SERVICE BULLETIN

SB1223

ADDRESSEES	: ABC Customer Care and Parts Source
COACH/BUS MODEL	: C2045
BULLETIN TYPE	: Product Improvement
SECTION/CHAPTER	: Section 11 – Body and accessories Chapter 10.54 Exterior parts
DATE	: October 7, 2009
SUBJECT	: Thermoplastic rear bumper – to address distortion issues
TERMS & CONDITIONS	: -

Figure 1

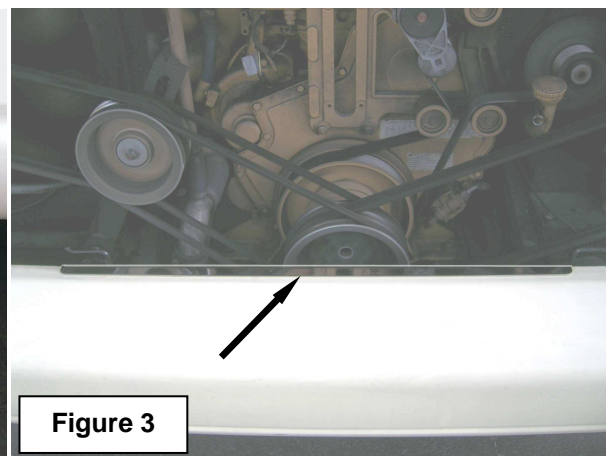
1. Rear bumper distortion has been reported on some of the above-mentioned units after they had been in service for some time (Figure 1).

2. Investigation indicates that here are two possible causes for this issue:

- The distortion may be caused by the difference in expansion rate between the thermoplastic bumper shell and the aluminum back-up beam to which it is bolted. When the shell has been secured too tightly to the beam and the ambient temperature rises considerably, the travel of the faster expanding shell is restricted by the slower expanding beam, resulting in buckling of the shell.
- The above-mentioned process may be magnified by the heat from the exhaust tailpipe(s), and to a lesser degree by the heat radiating from the engine.

This Service Bulletin has been released so distortion issues can be addressed by applying one or more of the procedures listed below.

- The first procedure explains how to check that the shell has been properly attached to the back-up beam and what should be done to correct the installation.
- The second procedure provides instructions on how to install an exhaust heat shield similar to the one that is standard equipment on model 2008 coaches (Figure 2).
- The third procedure shows how a finisher can be fitted to the top section of the bumper as a reinforcement and stiffener (Figure 3), should distortion hamper the opening of the engine compartment door.

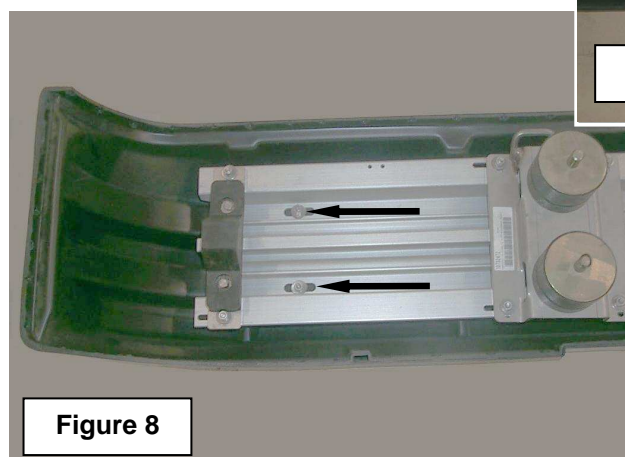
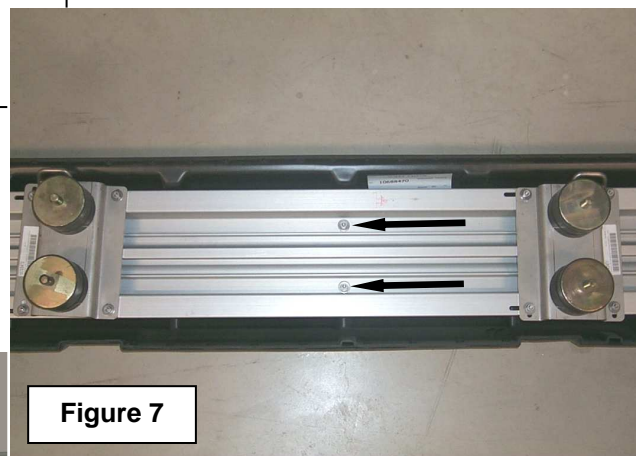
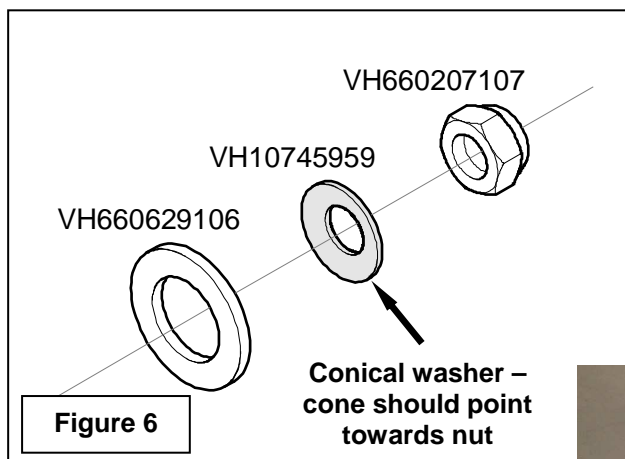
- 1) Check that the retaining nuts and washers have been properly installed.
The purpose is to make sure that that shell is anchored to the beam at the center and that movement is allowed at the ends.

- The fasteners should be fitted in the right order as shown in Figure 6.
 - The fasteners in the center (Figure 7) should be tightly secured.
 - The fasteners next to the left- and right-hand V blocks (Figure 8) should be tightened so that the washers fitted between the nut and the beam can hardly be shifted by hand.

- 2) If required, tighten the nuts in the center as follows:
 - Run-up the nuts and compress the washers until they can no longer be shifted by hand.
 - Tighten each nut further through 180°.
The conical washers are now properly tightened.

- 3) If required, tighten the nuts next to the V-blocks by running them up compressing the washers until they can hardly be shifted by hand.

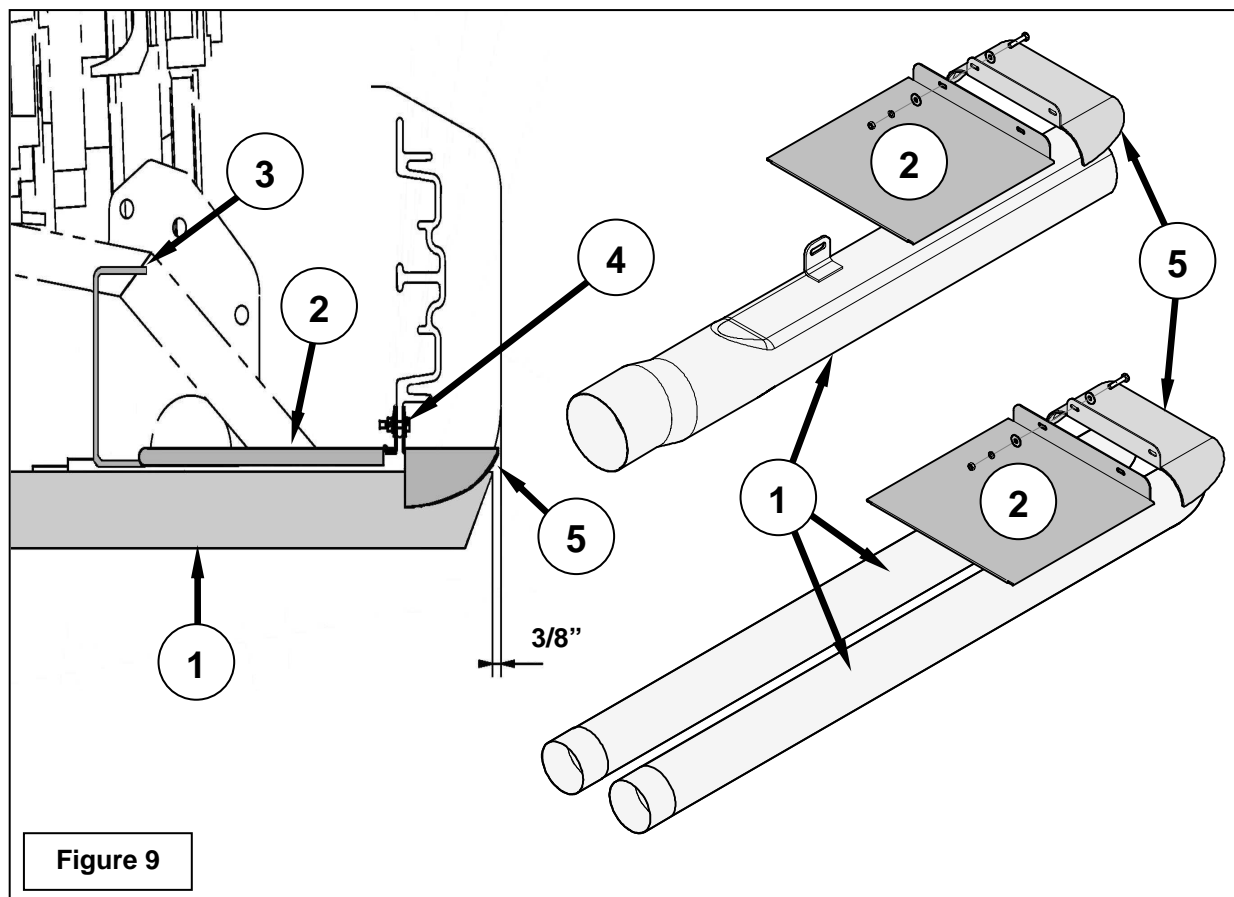
Reference is made to Figure 9. The exhaust heat shield sits approximately 9/16" above the tailpipe(s) (1) and comprises of two parts: a flat plate (2) that fits between the left hand rear-most U-channel (3) and the lower lip of the bumper beam (4), and a curved shell (5) that sits under the bumper and bolts to the beam and the flat plate.

- Carefully lever-off the tailpipe.
- 3) Place the curved shield in the recess of the bumper shell with the heat resisting cloth facing down.
- Make sure that the mounting lip of the shield rests against the lower lip of the bumper beam, and that there is an 5/8" air gap between the shield and the shell.

- With a scribe, mark the place of the two slotted holes provided in the shield lip onto the lower lip of the beam.
- Withdraw the shield.
- Using the marks of the slotted holes on the lower lip of the beam as a reference, drill a 1/4" diameter hole in the center of each mark.

- 4) Working inside the engine compartment, assemble and attach the curved and the flat heat shields with the heat resisting cloth facing down to the bumper beam.

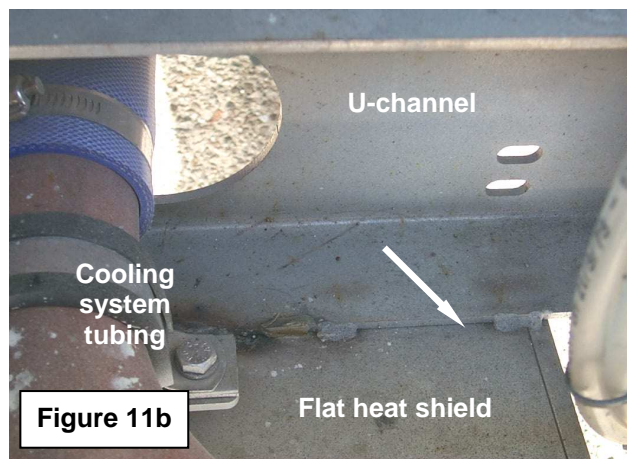
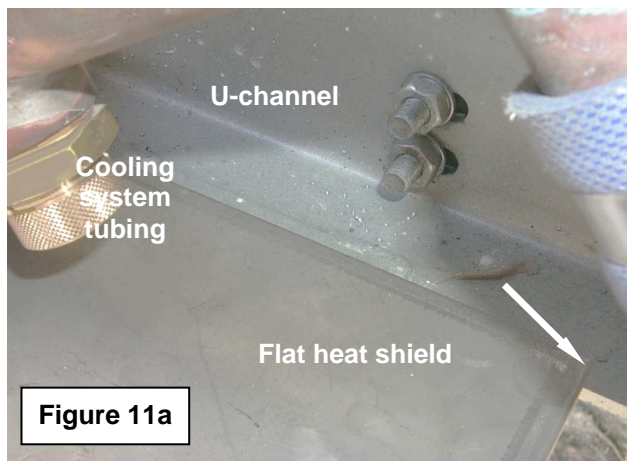
- 5) In production the radiator side of the flat shield is attached to the chassis U-channel by welding (Figures 11a and 11b).
- When retrofitting this shield in the field, it may be either bolted or riveted to the U-channel. Depending on the space available with respect to the engine cooling tubing, the shield can be fitted either resting on (Figure 11a), or hanging from the U-channel flange (Figure 11b).

- 6) At the back-up beam, run-up the nuts and tighten the heat shield retaining bolts to a torque of 80 in.lbf (8.6 Nm).
- 7) At the U-channel attach the shield by bolting or riveting, whichever is the most suitable.
- 8) Reinstall the tailpipe(s) in reverse order to removal.
